R. E. GINNA NUCLEAR POWER PLANT

AMENDMENT TO PROVISIONAL OPERATING LICENSE

Amendment No. 65
License No. DPR-18

ATTACHMENT TO LICENSE AMENDMENT NO. 65

FIGURE 5.4-1
SPENT FUEL STORAGE RACKS

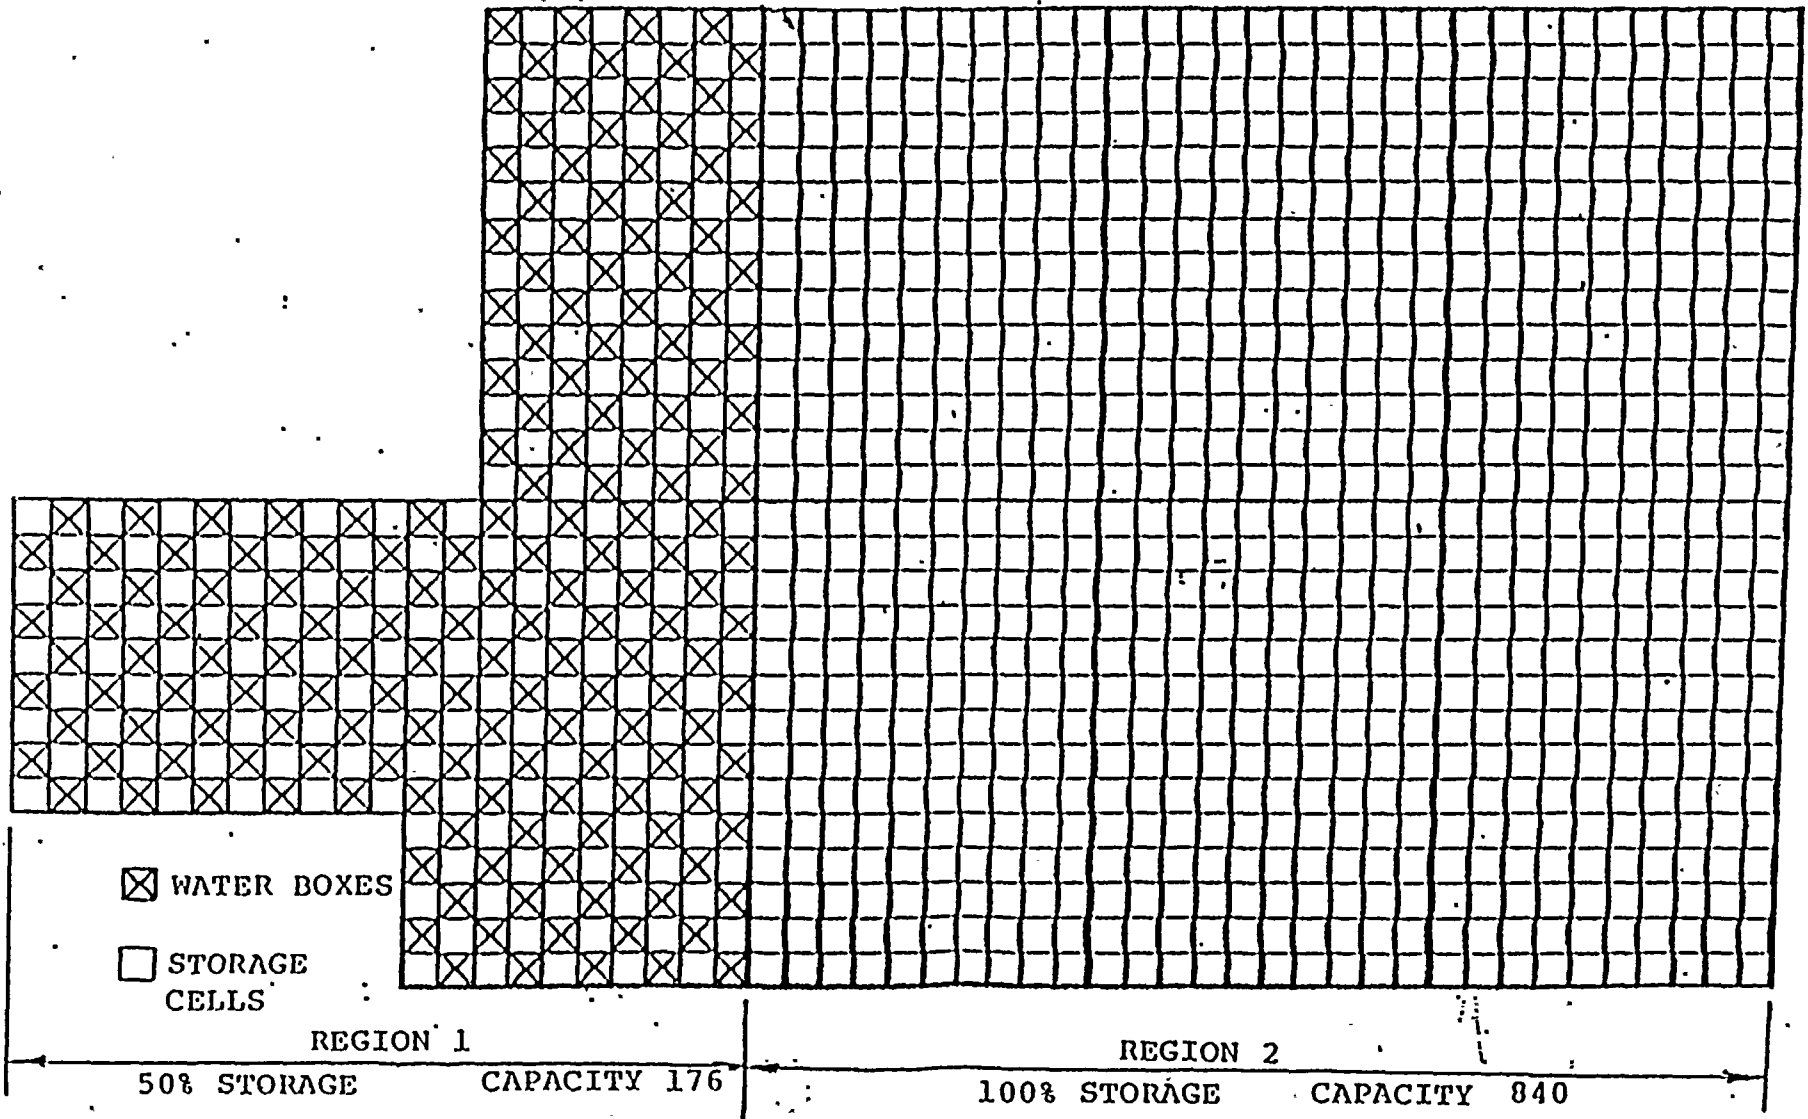
- 5.4.2 The new and spent fuel storage racks are designed so that it is impossible to insert fuel assemblies in other than the prescribed locations. The spent fuel storage racks are divided into two regions as depicted on Figure 5.4-1. The fuel is stored vertically in an array with sufficient center-to-center distance between assemblies to assure $K_{eff} \leq 0.95$ for (1) unirradiated fuel assemblies delivered prior to January 1, 1984 (Region 1-15) containing no more than 39.0 gms U-235 per axial cm, and (2) unirradiated fuel assemblies delivered after January 1, 1984 containing no more than 41.9 gms U-235 per axial cm. Both cases assume unborated water used in the pool.

REGIONS OF ACCEPTABILITY AND UNACCEPTABILITY
FOR STORAGE OF SPENT FUEL IN REGION 2

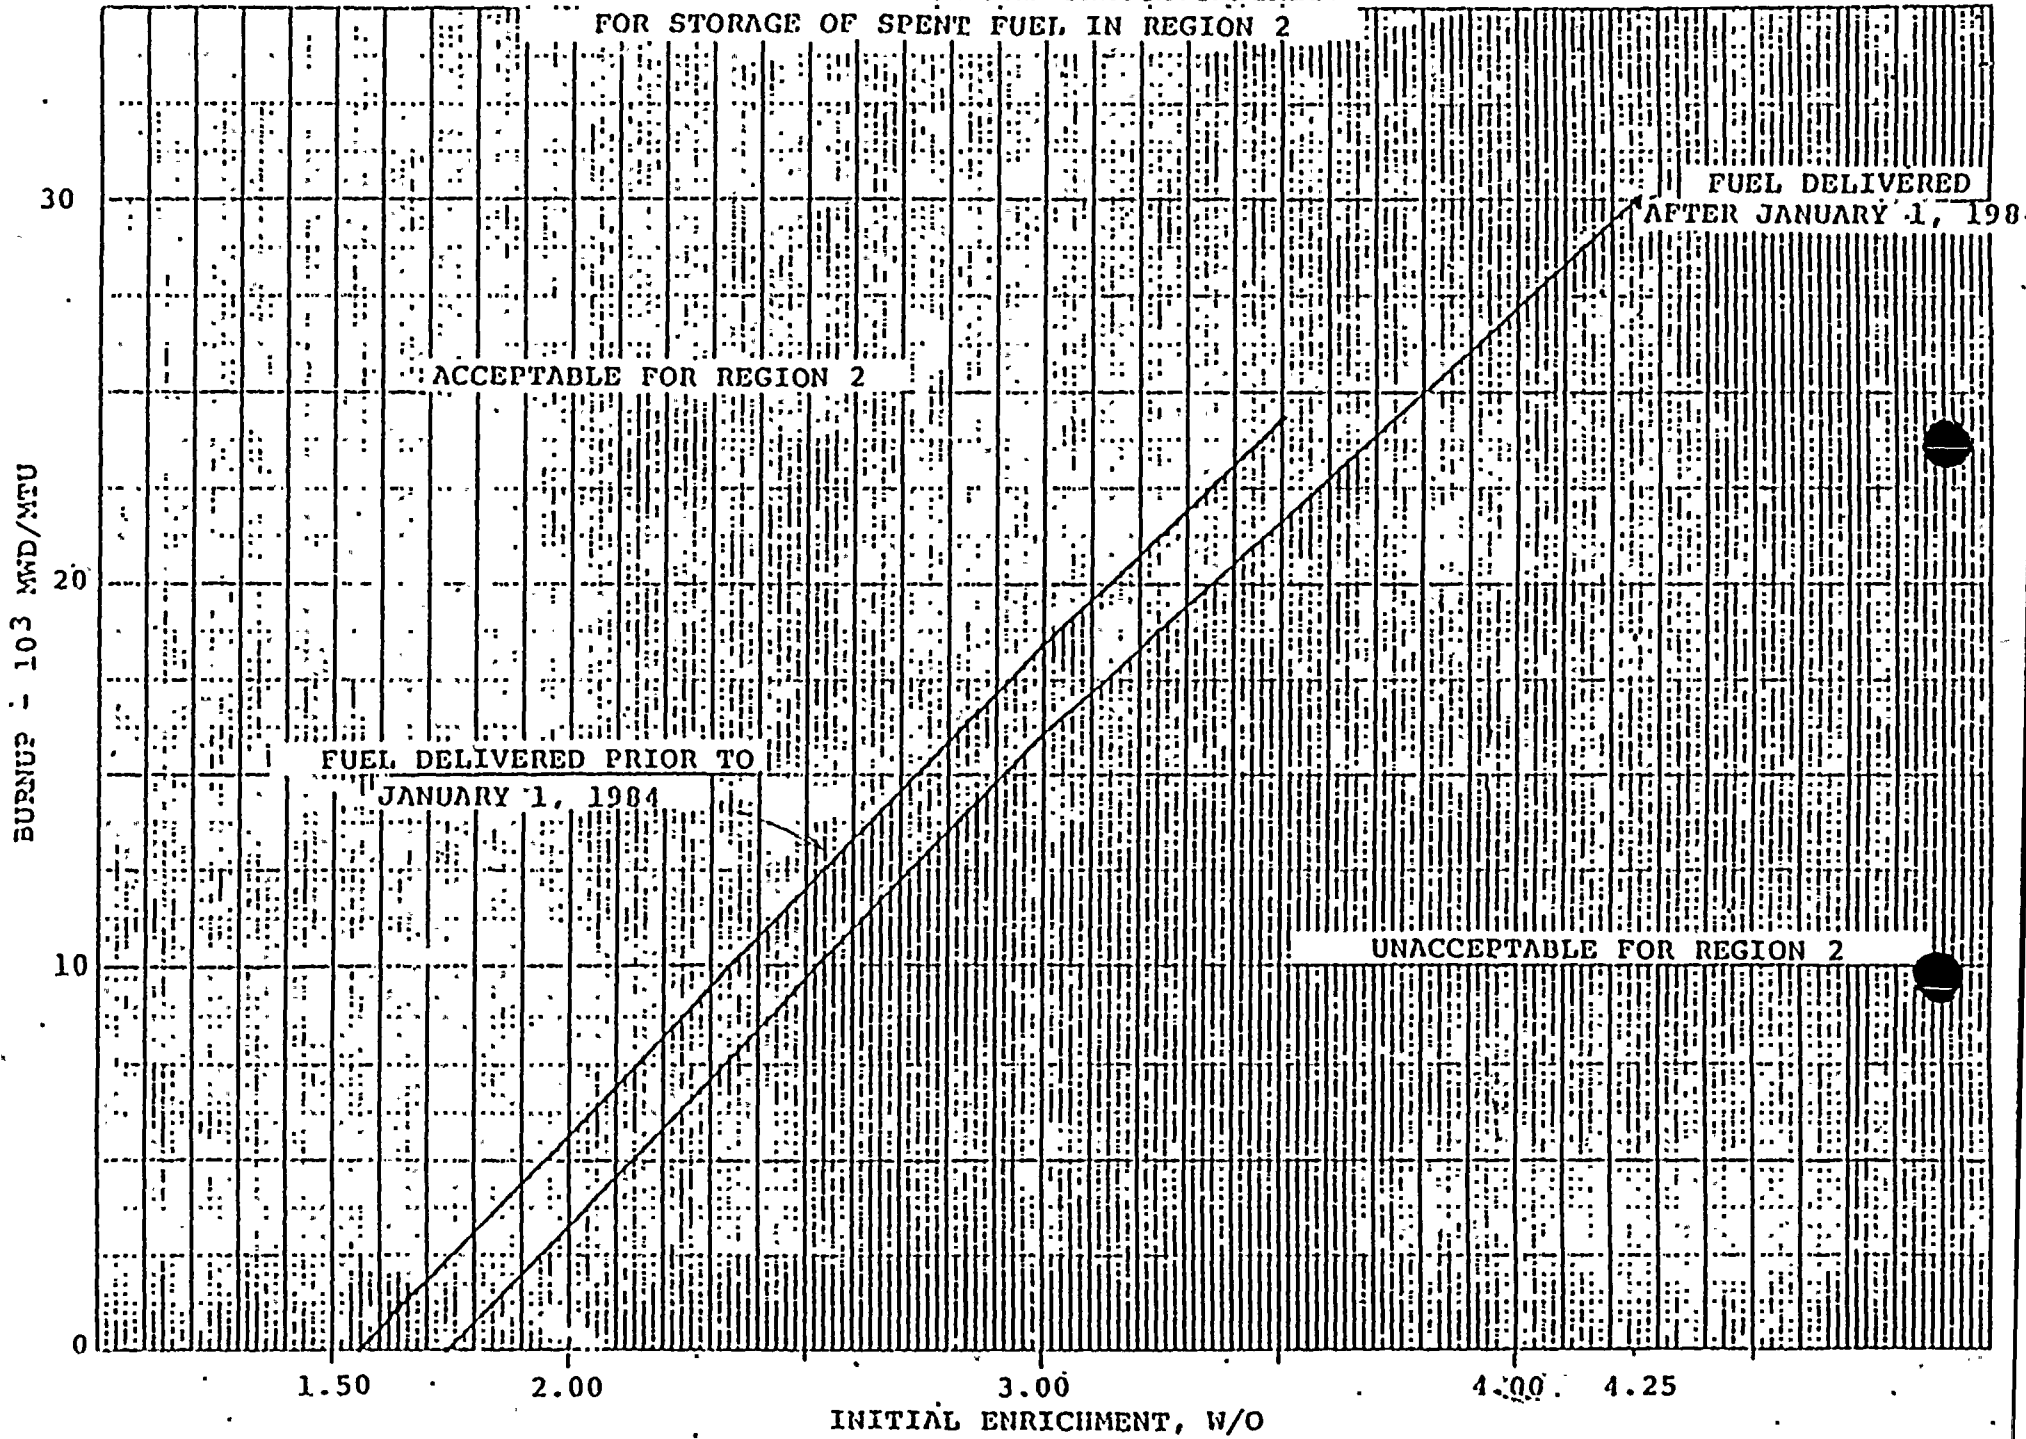
- 5.4.3 In Region 2 of the spent fuel storage racks, fuel is stored in a close packed array utilizing fixed neutron poisons in each of the stored locations. For discharged fuel assemblies to be stored in Region 2, (1) 60 days must have elapsed since the core reached hot shutdown prior to discharge and (2) the combination of assembly average burnup and initial U-235 enrichment must be such that the point identified by these two parameters on Figure 5.4-2 is above the line applicable to the particular fuel assembly design, therefore assuring that $K_{eff} \leq 0.95$.

The two curves of Figure 5.4-2 divide the fuel assembly designs into two groups. The first group is all fuel delivered prior to January 1, 1984. This incorporates all Exxon and Westinghouse HIPAR designs used at Ginna⁴. The second curve is for the Westinghouse Optimized Fuel Assembly design delivered to Ginna beginning in February 1984³.

associated with the time between measurements and updates of core burnup. The curves of Figure 5.4-2 incorporate the uncertainties of the calculation of assembly reactivity.³

The calculations of fuel assembly burnup for comparison to the curves of Figure 5.4-2 to determine the acceptability for storage in Region 2 shall be independently checked. The records of these calculations shall be kept for as long as fuel assemblies remain in the pool.
